## **API 521 9<sup>th</sup> Edition Ballot**

### **Review the use of Shall and Must (Work Item #11)**

## Pressure-relieving and Depressuring Systems

**Figure 7—Flare Gas Recovery Inlet Pressure**

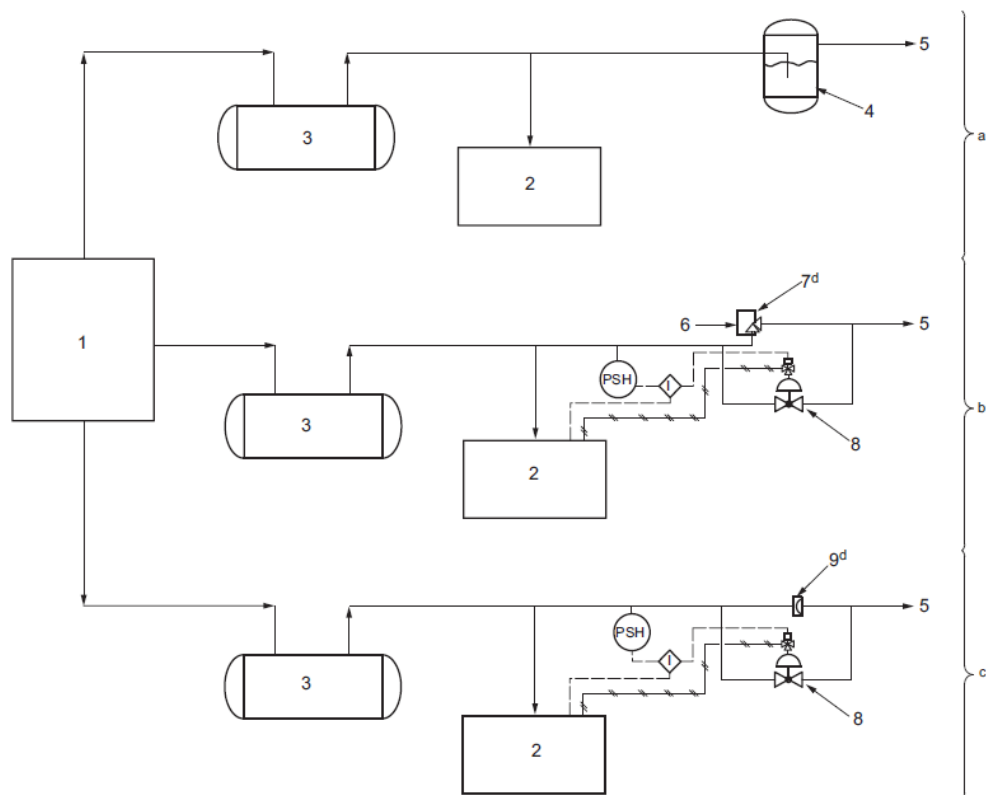
when the compressors are unloaded or shutdown. These interlocks ~~are shall not a be~~ substituted for a positive path around the control valve, as described above.
